SERVICE BULLETIN No BE-010/SZD-59/2009 "ACRO"

DESIGNATION-TYPE/MODEL: SZD-59 "ACRO"

CONCERNS: Inspection of the fuselage frame joints.

Fig.1. Cracks location.

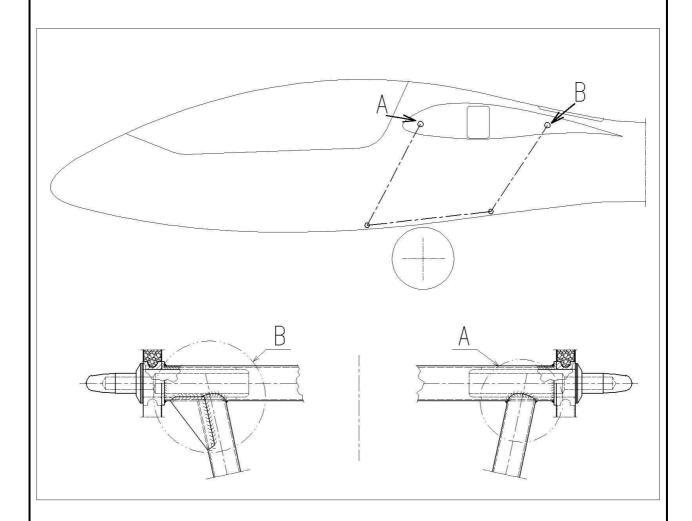
In 4 SZD-59 gliders a cracks of the fuselage frame tube has been detected, at the front wing fixing point, near welded joint.

By the cockpit's cutout the front frame tube at welded joints, next to the front wing fixing pivots (see Fig.1, A)is to be inspected by visual methods. All circumference of the tube is to be inspected. By the sighthole between wings, rear frame tube is to be inspected, at the welded joints (see Fig.1, B). All circumference of the tube is to be inspected. For rear tube inspection, tools like a digital camera, endoscope or similar can be necessary. In a case of a crack is found, the glider is to be found non-airworthy until a repair is done, and the operator of a glider is requested to report the case to the manufacturer. Please enclose following information: serial number of the glider, total flight time and total amount of landings.

- 5.1. The inspection of the front tube is to be repeated before every day of flying. The inspection of the rear tube is to be repeated after each 5 flying days.
- 5.2. The repair method will be given by a separate bulletin.
